1 14. (Amended) A lead frame for an integrated circuit chip having a frame engaging  
2 bottom surface comprising:  
3 an apertured frame said frame being generally circular and defining a peripheral edge and  
4 having a contact surface for securing the chip thereto, said edge being disposed within an outer chip  
5 edge for minimizing fillet formation.

### REMARKS

## VERSION WITH MARKINGS TO SHOW CHANGES MADE

FIG. 1A

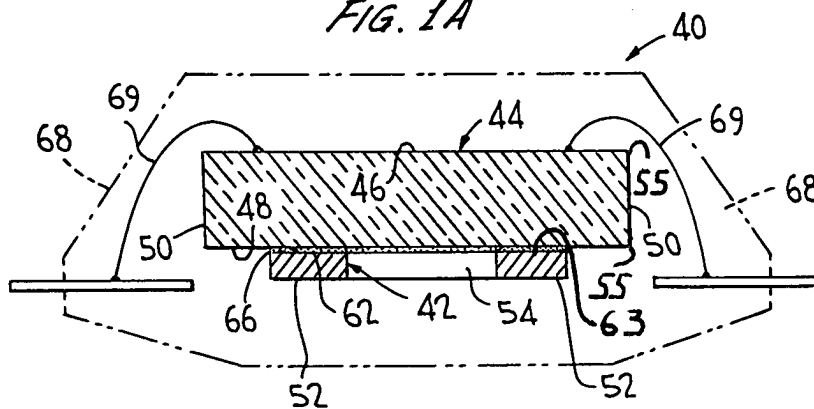
The drawings are objected to because "reference signs 55, 63 and 88 are not shown." Applicants file herewith a separate Request for Approval of Drawing Corrections which includes amendments to Fig. 1A. Applicants respectfully traverse this objection with respect to reference sign 88.

*FIG. 6*

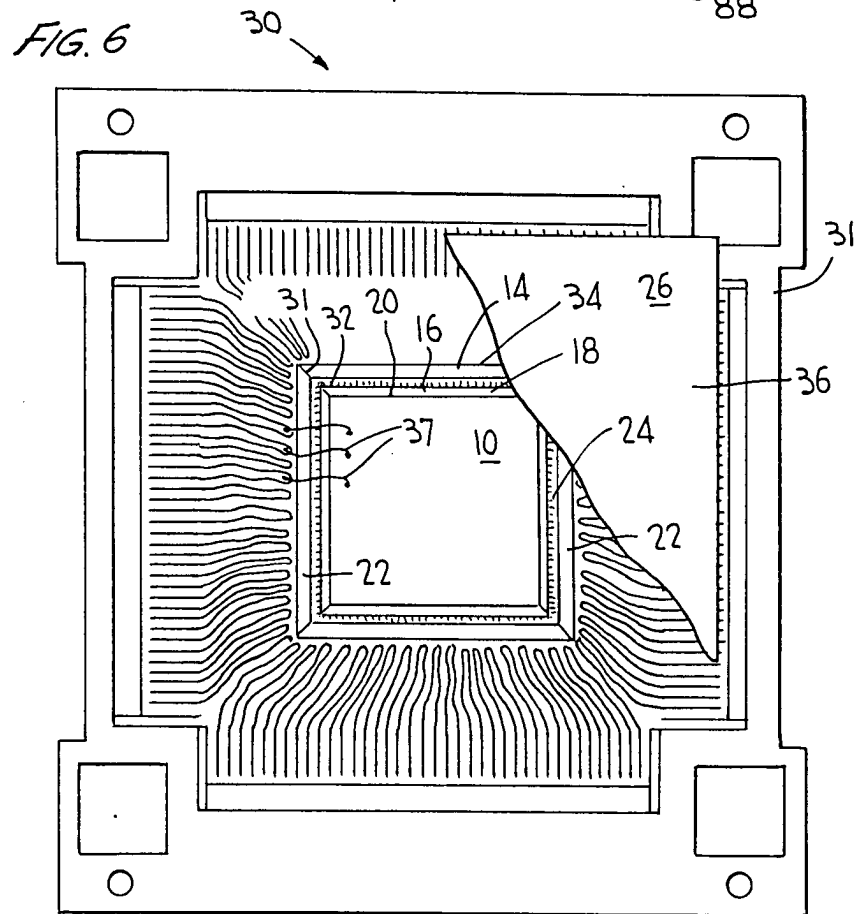
Figs. 6, 6A and 6B are objected to because "they should be designated by a legend such as --Prior Art--." Applicants file herewith a separate Request for Approval of Drawing Corrections which includes amendments to Figs. 6, 6A and 6B.

*PRIOR ART*
